# Access Compliance Report

## Public Rights-of-Way

### (Curb Ramps)

Intersection ID: 17770	Main Street: LORENE_AV	Cross Street: ROSWELL_AV	Location: SW
ADA ID: ED8328D44174	Ramp Type: Directional1	Initial Pass/Fail: Fail	Overall Compliance: No
		Severity Score: 25

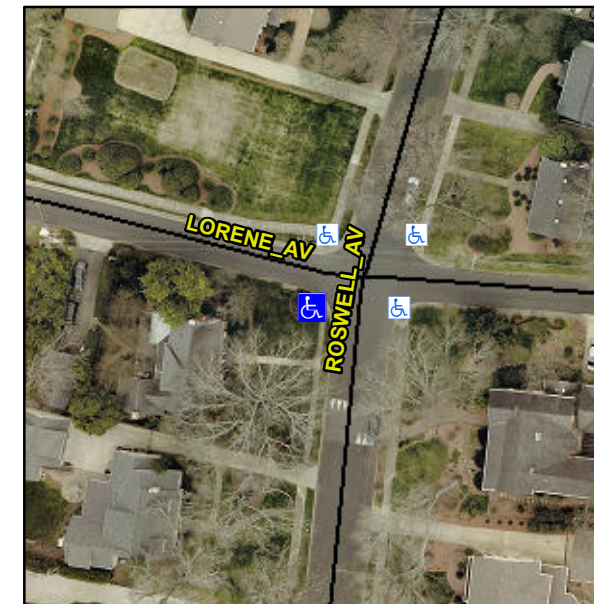
**VEGETATION OVERGROWTH**

**R304.5.3**

Compliance	Description	Data	Compliance	Description	Data
N/A	Ramp Length (in)	63.0	N/A	Grade Break?	N/A
Yes	Ramp Width (in)	60.0	N/A	Grade Break Slope (%)	0.0
Yes	Ramp Slope (%)	5.3	N/A	Grade Break XSlope (%)	0.0
No	Ramp XSlope (%)	7.5			
N/A	Flare Type LT	N/A	N/A	Flare Type RT	N/A
N/A	Flare Slope LT (%)	N/A	N/A	Flare Slope RT (%)	0.0
N/A	Flare Traversable LT?	N/A	N/A	Flare Traversable RT?	N/A
N/A	Landing Length (in)	0.0	N/A	DWS Provided?	N/A
N/A	Landing Width (in)	0.0	N/A	DWS Contrast?	N/A
N/A	Landing Slope (%)	0.0	N/A	DWS Length (in)	N/A
N/A	Landing X Slope (%)	0.0	N/A	DWS Full Width?	N/A
N/A	Landing Curb? (Y/N)	N/A	N/A	DWS Offset LT (in)	N/A
N/A	Shared Landing?	N/A	N/A	DWS Offset RT (in)	N/A
N/A	Gutter Ponding?	0.0	N/A	Gutter Slope (%)	N/A
N/A	Gutter Lip Ht (in)	0.0	N/A	Gutter X Slope (%)	N/A
N/A	Painted X Walk1?	No		Road Slope (%)	3.2
	X Walk 1 Direction	To N		Road X Slope (%)	4.5
	X Walk 1 Width (in)	N/A		Clear Space?	N/A

**Remove & Replace Entire Ramp.**
